AFT CG RESTRICTION

Ident.: TDU / LIM-WGHT-00010658.0051001 / 19 JUL 19

FLIGHT OPERATIONS TRANSMISSION - FOT

SUBJECT: ATA 27 – LIMITATION OF THE AFT CG ENVELOPE

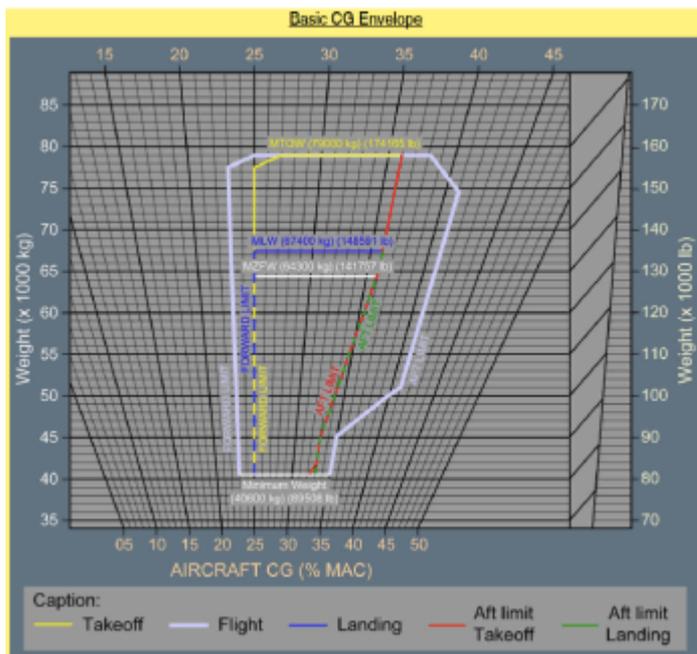
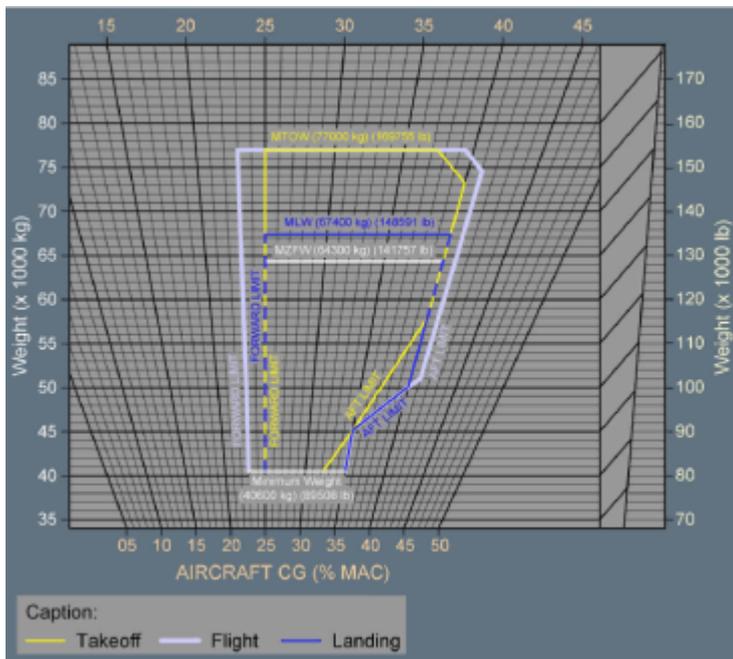
The aft CG limit of the aircraft for takeoff and landing must be restricted according to the aft CG limit shown in the CG envelopes below.

Note: The CG envelopes shown below correspond to the highest certified MTOW, MLW and MZFW. For the certified MTOW, MLW and MZFW applicable to the aircraft, refer to the Weight Variant in the Weight Limitations chapter. Except for the aft CG limit, the CG envelopes according to the aircraft Weight Variant remain valid.

New restriction

New CG range with the basic FWD CG

Old CG limit

The purpose of this FOT is to provide operators with information on the new limit of the AFT CG for take-off and landing for the A320neo (AFM Temporary Revision - TR ref 773, 774,775 and 776).

The above-mentioned AFM TRs limit the CG envelope during takeoff and landing.

- Follow forward cargo loading practices by:
 - Prioritize the forward compartments (1&2)
 - Minimize the use of the aft compartments (3&4)
 - Limit the use of compartment 5 (bulk)
- Limit the amount of catering supplies stowed in aft galleys (trolleys)
- Consider passenger seating allocation prioritized to forward cabin
